Hydraulic Laboratory Technical Memorandum PAP-1087

Clark's Fork Coalition & Watson Irrigation Fish Screen Tests

Comments and Responses to Client Review

RE: COMMENTS on “Clark Fork Coalition and Watson Irrigation Fish Screen Tests,” by Bureau of Reclamation Hydraulic Laboratory, Denver, CO, January, 2014.

Figure 6 – Estimated velocity distribution through the screen for the initial evaluation. No physical measurements were obtained. Flow arrows are not proportionate and only represent direction and approximate magnitude. Red section is the screen, Flow is from left to right.

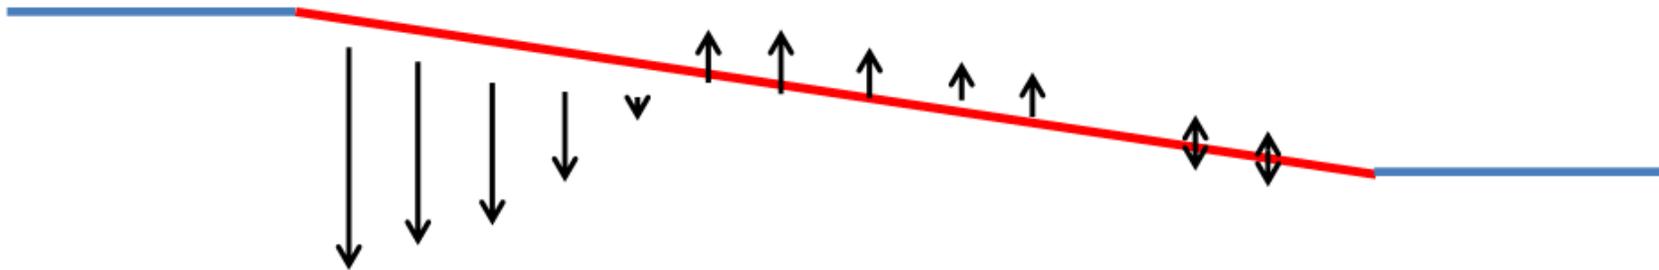
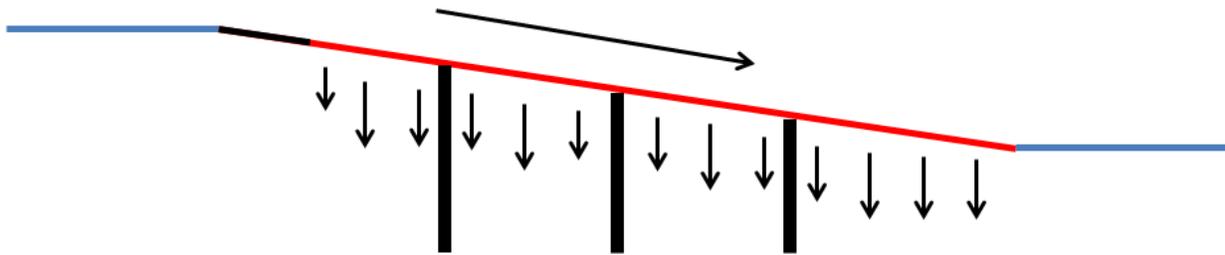
7. Can the report say anything more about the hydraulic conditions on the screen face based on observations and the depth measurements?

See item 6 above and the clarity added to Figures 6 & 9 in the text. To avoid any misrepresentation of physical data no other information is provided.
